SUMMARY

Applicant James Petersen SE Surveying & Mapping, Inc. Owner	Property Location: 5601 Butler National Dr. (west side of S. Semoran Blvd., between Leevista Blvd. and Butler National Dr.) (parcel # 21-23-30-2285-00-010; 19.45 acres, District 1).	
Nathan Cohen, LR Butler Natl. Dr. Orlando, LLC	Applicant's Request: The applicant proposes to replat a partially developed property for the ongoing commercial redevelopment of said	
Project Planner Jim Burnett, AICP	property. The property is located in the Airport North neighborhood.	
Updated : May 1, 2014	Staff Recommendation: Approval of the Minor Plat, subject to conditions in this staff report.

PROPOSED PLAT

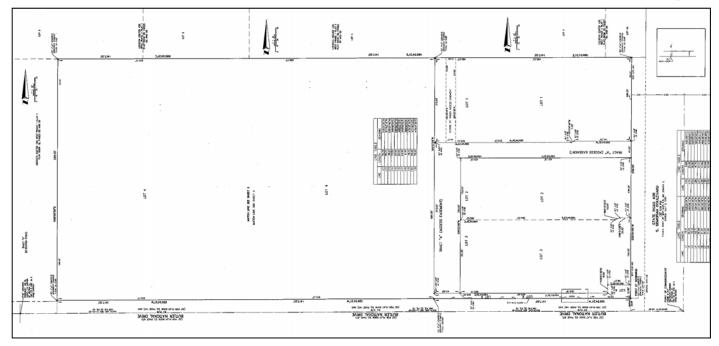
- 1. Surveys Signed and sealed boundary and topographic surveys are required for this project.
- 2. In General Note #4 on Sheet 1 of 4, the ownership and party responsible for maintenance of this tract shall be provided.

- 3. Plat Face Changes: In addition to the changes required on the plat, the following is a list of additional requirements:
 - a) Any changes to the face of the plat requested via the conditions of this report.
